**AMENDMENTS TO THE DRAWINGS:**

## **REMARKS**

### **I. Objection to the Drawings**

ANNOTATED SHEET

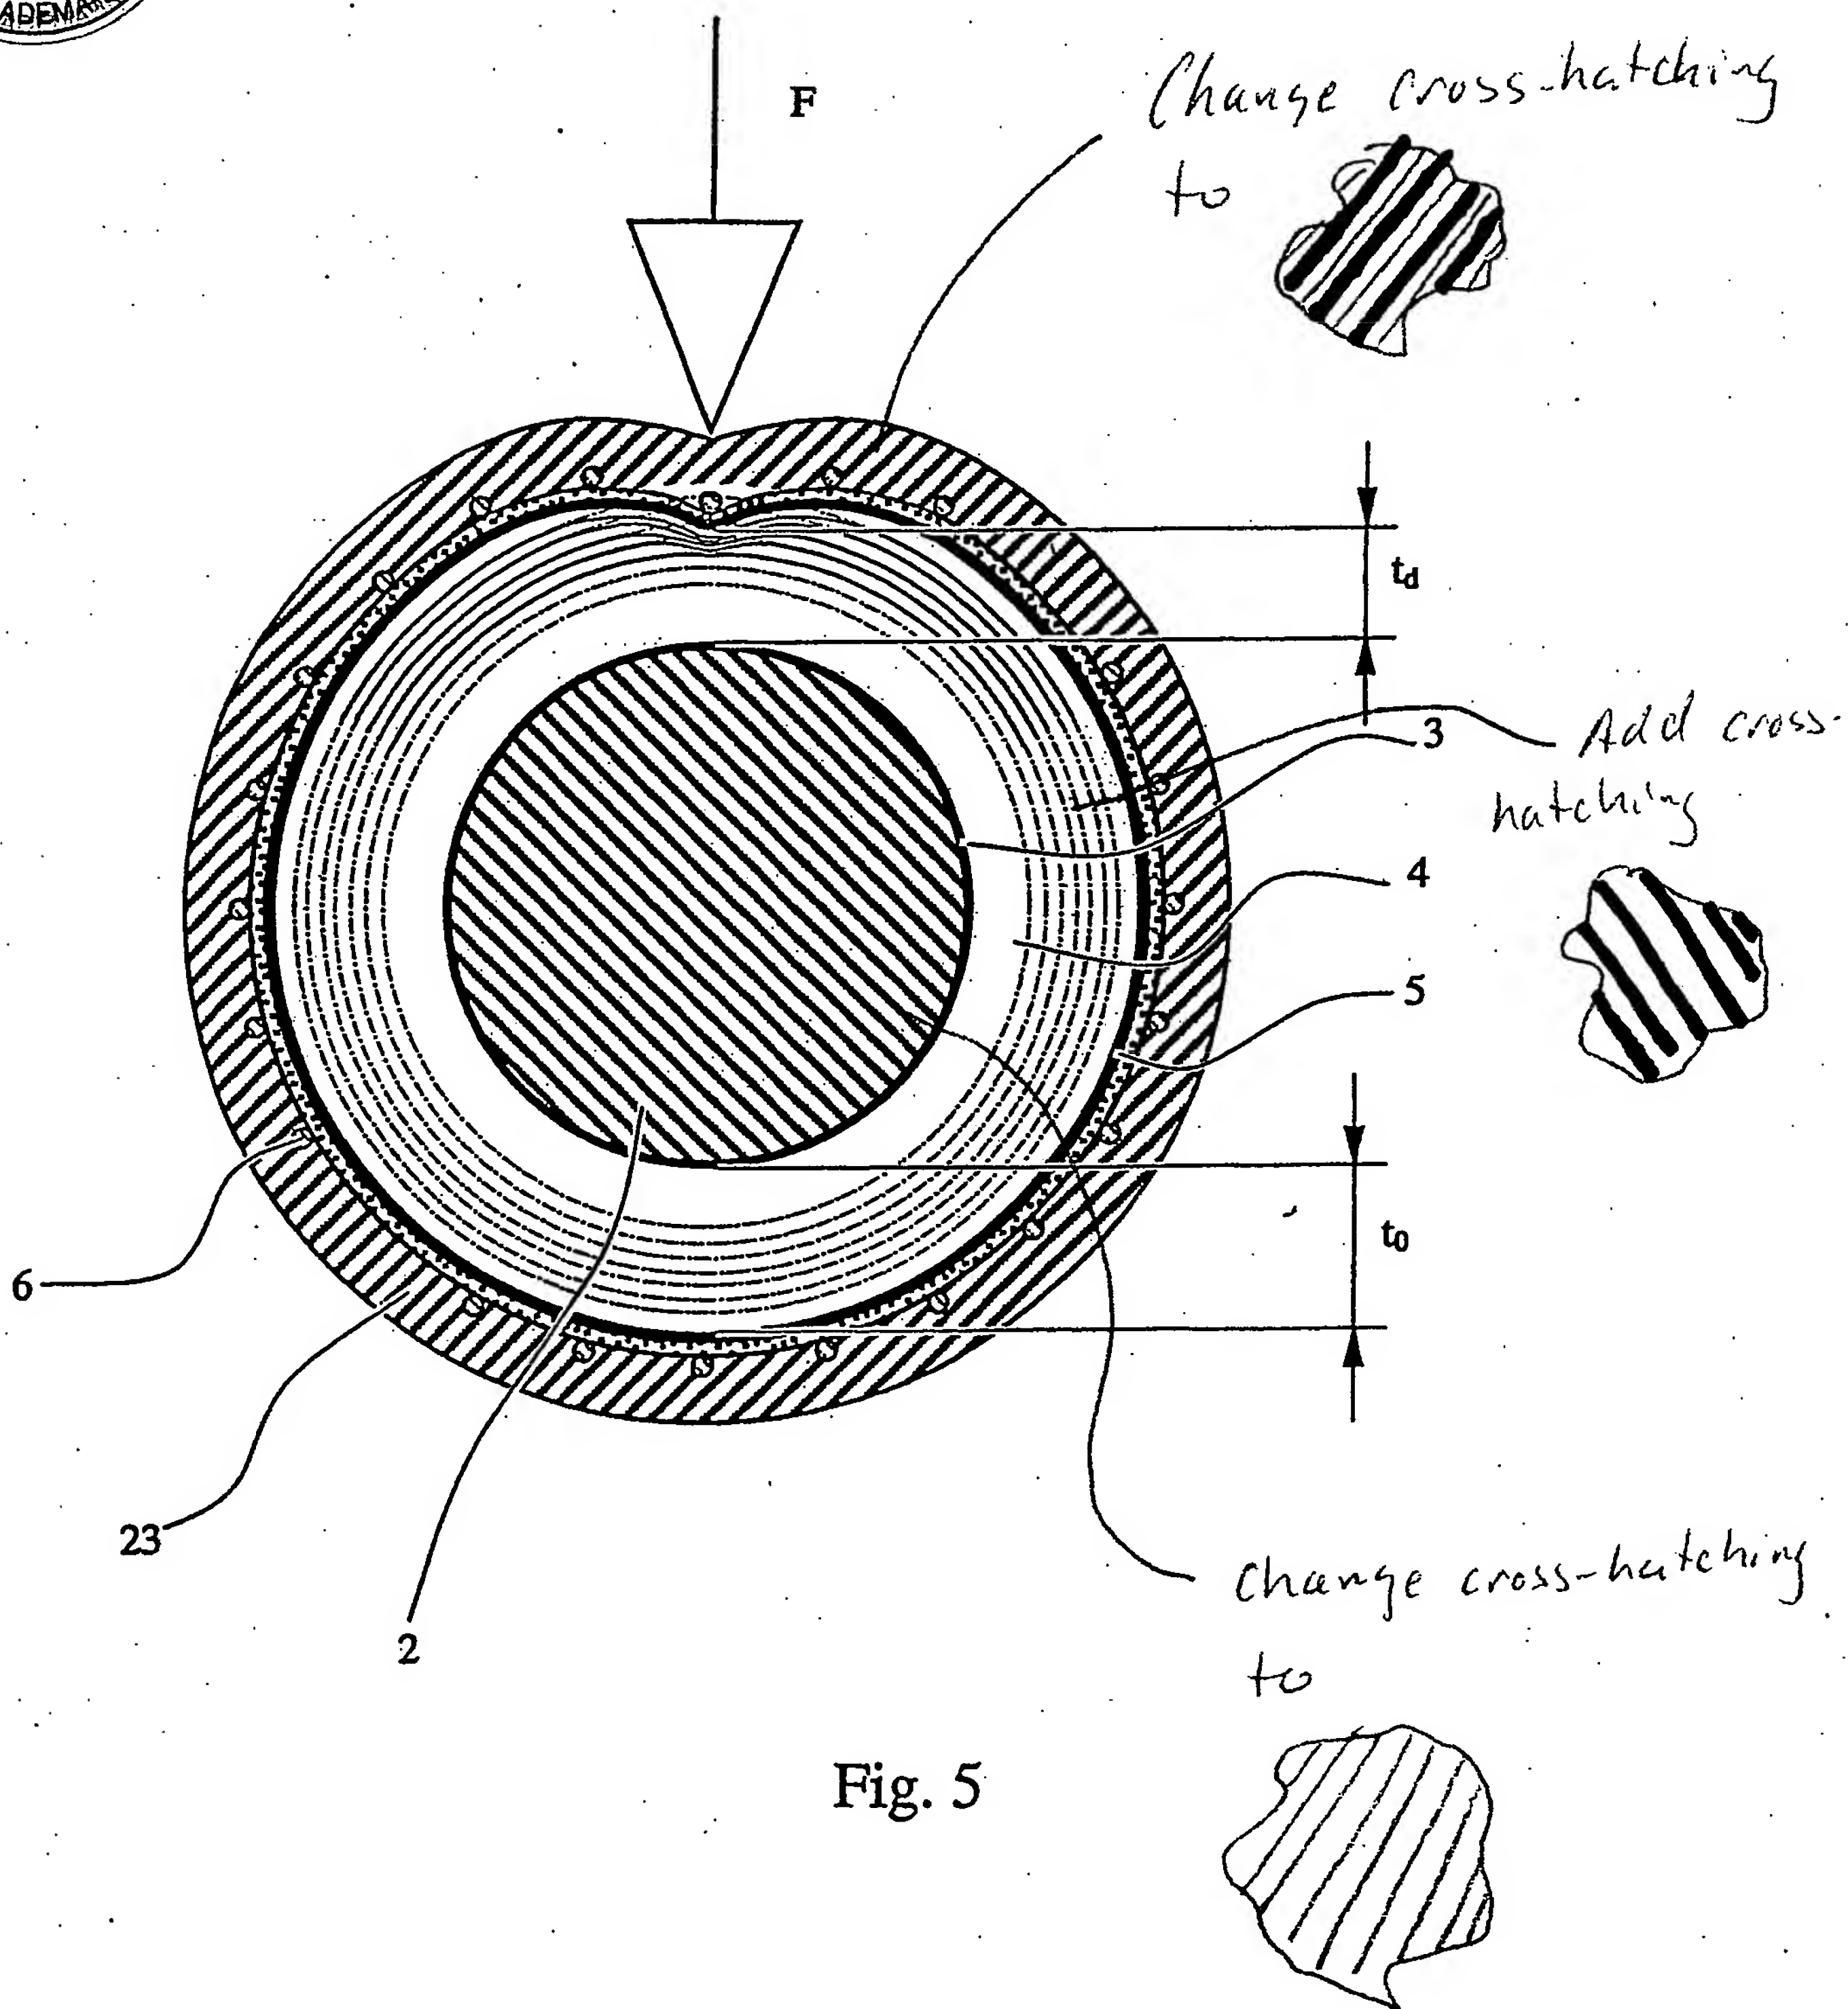
The drawings were objected to "because Figures 5-6 lack[] the proper cross-hatching which indicates the type of materials, which may be in an invention. Office Action at 2. Applicants have amended Figs. 5 and 6, such that those drawing figures comply with the symbol requirements of M.P.E.P. § 608.02. Applicants respectfully submit that the claims should not be interpreted based on inferences relating to the cross-hatching symbols designated in M.P.E.P. § 608.02 and added to Figs. 5 and 6, which show exemplary embodiments. Rather, the claims should be interpreted based on the broadest reasonable interpretation consistent with U.S. practice of the terminology recited in the claims themselves. Applicants respectfully request reconsideration and withdrawal of the objection to the drawings.

Please amend the drawing figures as indicated on the two Annotated Sheets attached to this Amendment, which are marked-up copies of the drawing sheets containing Figs. 5 and 6. As indicated in the Annotated Sheets, Applicants have amended Figs. 5 and 6, such that those drawing figures comply with the symbol requirements of M.P.E.P. § 608.02. Applicants have also attached two Replacement Sheets, which incorporate the changes shown on the two Annotated Sheets.
